<b>CREATIVE ENERGY BEATTY/EXPO PLANTS CPCN AND REORGANIZATION EXHIBIT A-18</b>
--

**Re: Creative Energy Vancouver Platforms Inc. – Application for Certificate of Public Convenience and Necessity for the Expo–Beatty Plants and Reorganization – Project Number 1598962 – BCUC Information Request No. 2**

**INFORMATION REQUEST NO. 2 TO CREATIVE ENERGY VANCOUVER PLATFORMS INC.**

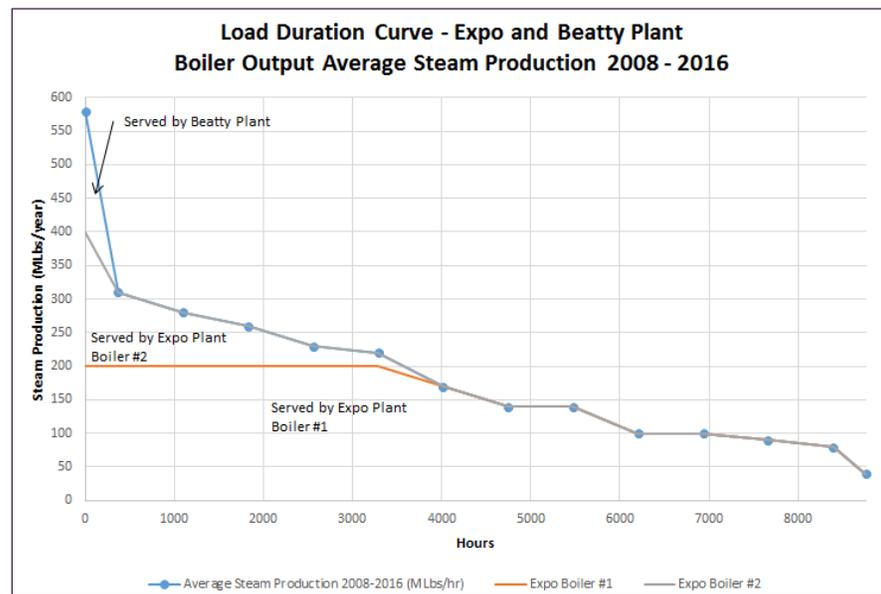
99.1 Please discuss how the replacement of some steam-powered equipment with electricity-powered equipment will impact the ‘Plant Load at peak demand’.

99.1.1 If the replacement is anticipated to impact the ‘Plant Load at peak demand’, please provide the updated figure.

- 99.1.1.1 Please explain how the figure was calculated and provide all assumptions made.
- 99.1.2 If the replacement is not anticipated to impact the Plant Load at peak demand, please explain why.
- 99.1.3 Please provide an updated table to reflect the information provided in response to IR 99.1.1.
